RE: Nitsch Project #10079  
Continuation of Use  
37 Knox Trail  
Acton, MA

On behalf of Concord Public Schools, Nitsch Engineering is pleased to submit revised plans based on Town of Acton's comments for the Application for Continuation of Use at 37 Knox Trail in Acton, Massachusetts. Comments were received from the Acton Engineering Department, Zoning Enforcement and Assistant Town Planner, Water Supply District of Acton, and the Acton Fire Department. Nitsch Engineering is providing the following information for your review:

## RESPONSES TO ENGINEERING DEPARTMENT COMMENTS

**C4.0**

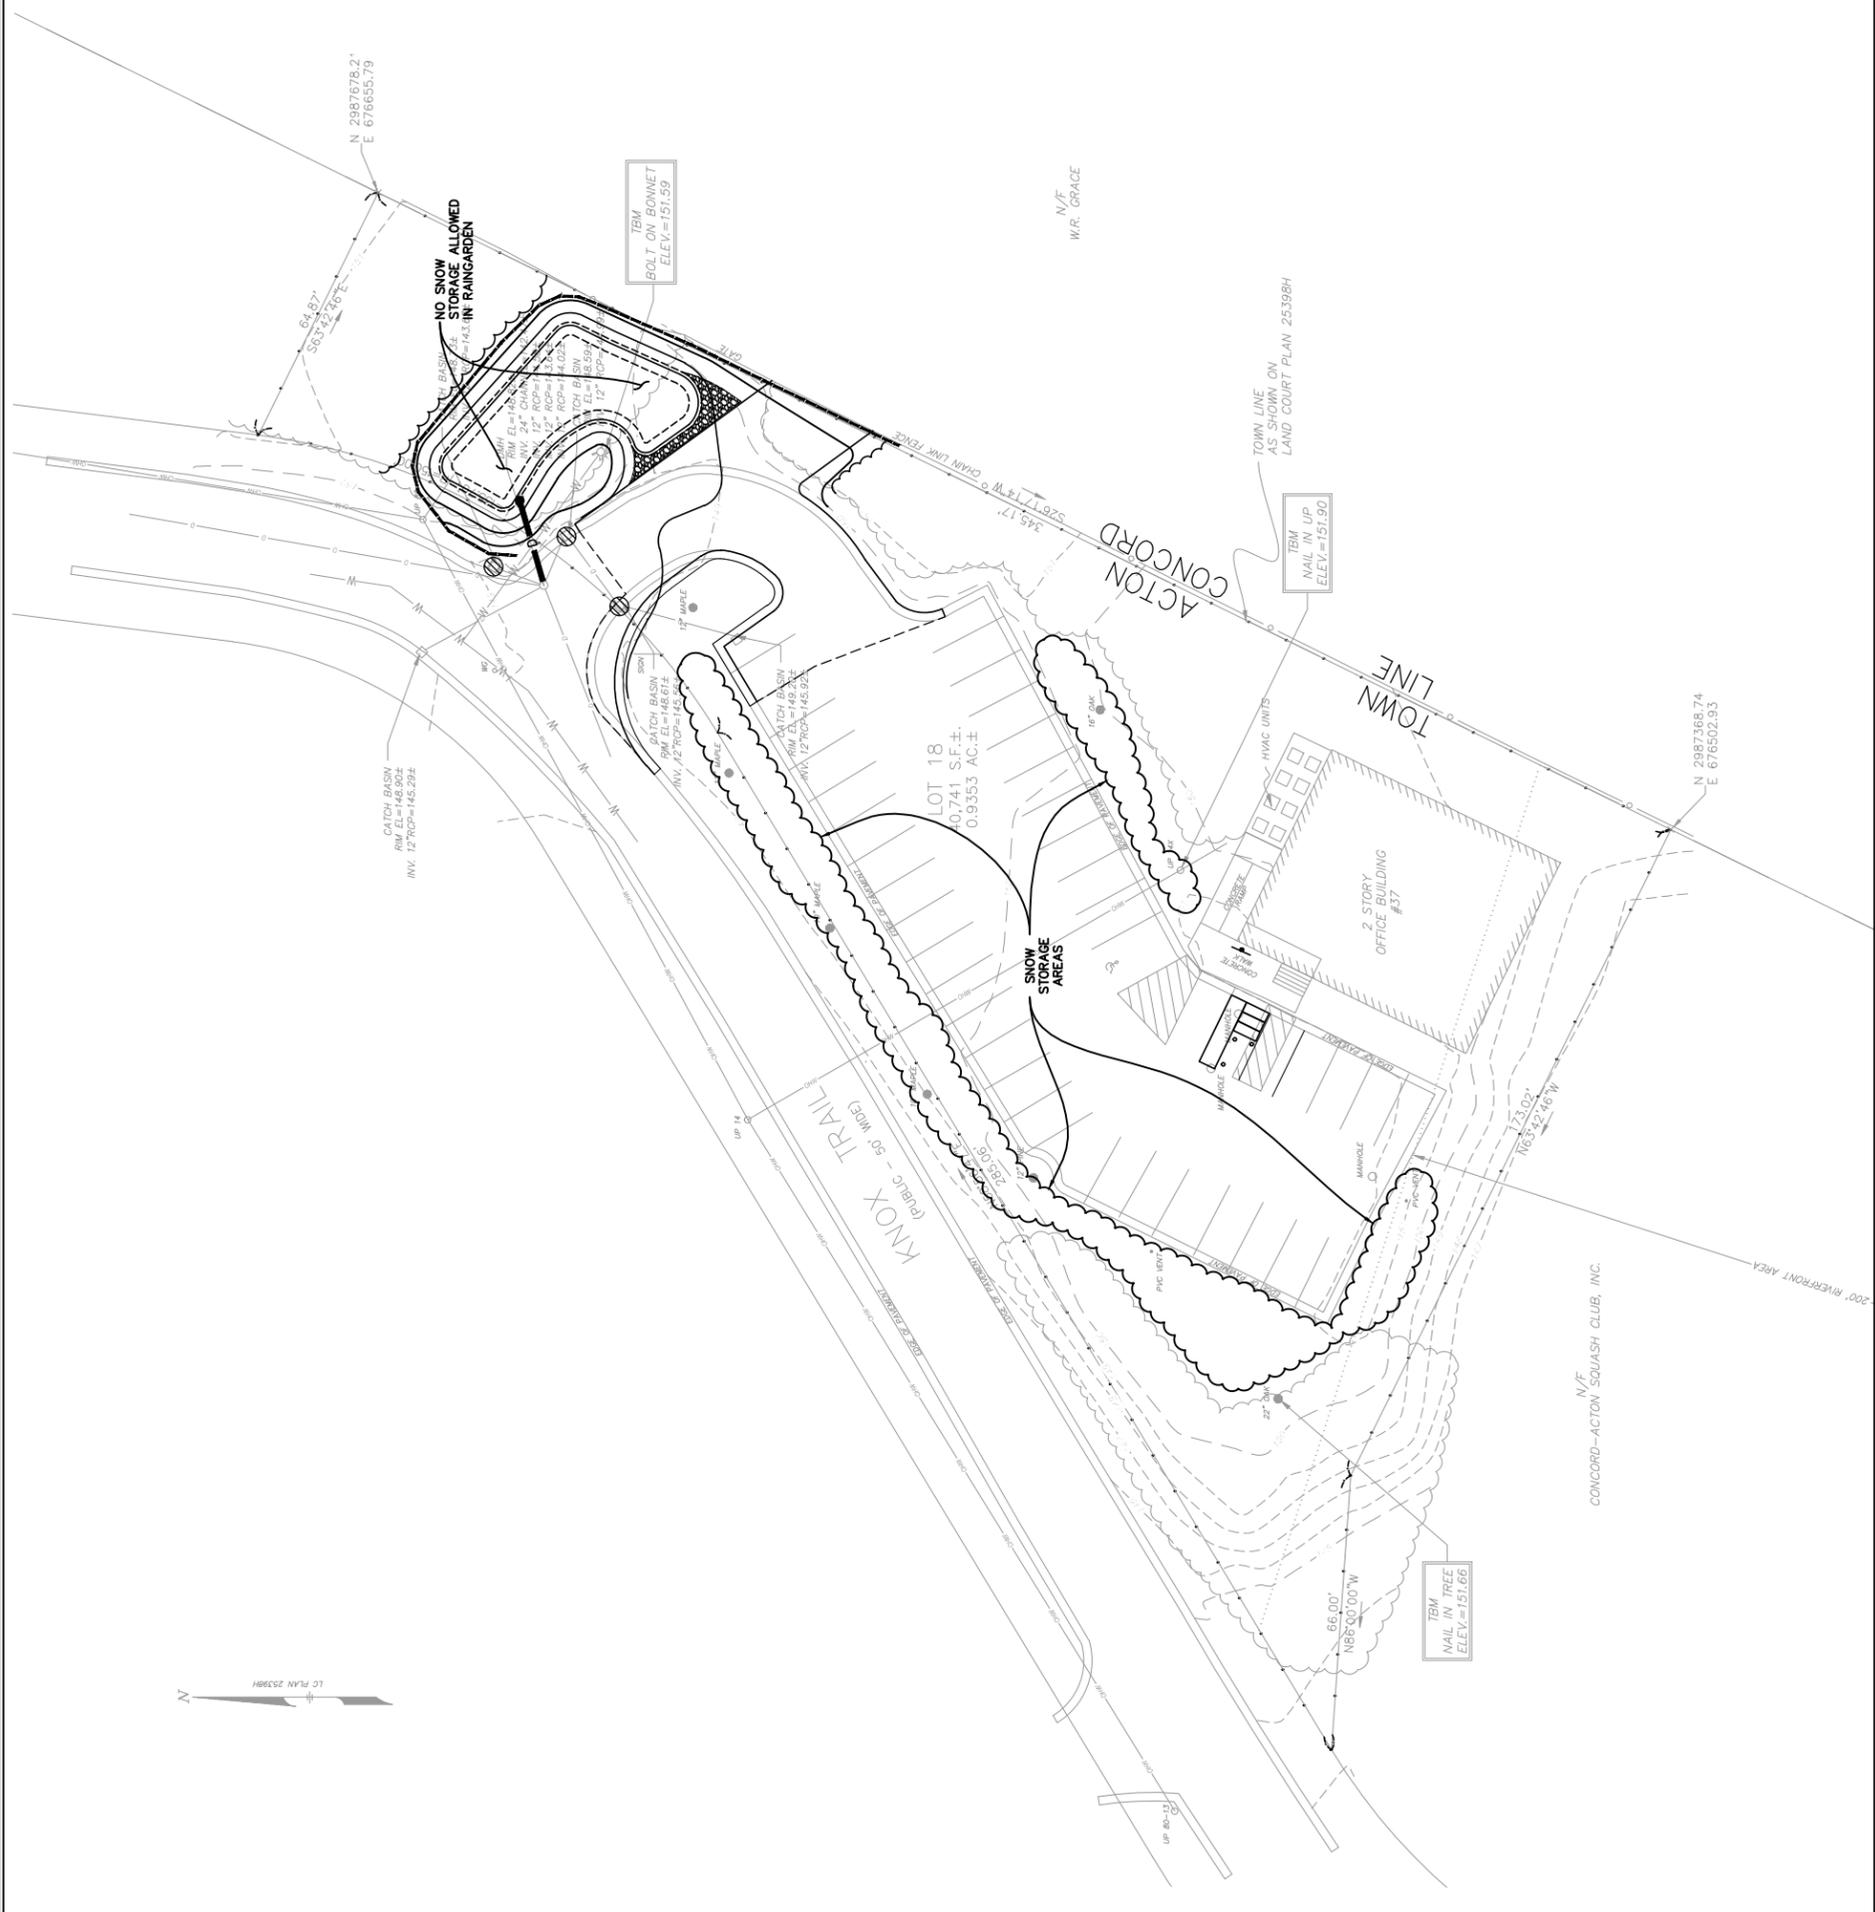
3. Nitsch Engineering performed a test pit in accordance with the Stormwater Handbook Regulations and found that the area for the rain garden is a well-drained soil (hydrologic soil group of A). Nitsch Engineering used an infiltration rate of 2.41 inches per hour which is more conservative than the 8.27 inches per hour allowed by the Stormwater Handbook. In addition, groundwater and seasonal high groundwater was not observed after digging 10 feet below grade. A trench permit was applied for and received on October 14, 2014 for this work.
4. Nitsch Engineering provided revised pre- and post-development HydroCAD calculations for review.
9. Nitsch Engineering notes that the Town of Concord agrees to contribute to the sidewalk fund.
11. Nitsch Engineering provided a revised snow storage plan, Sheet C-4.0, as requested.
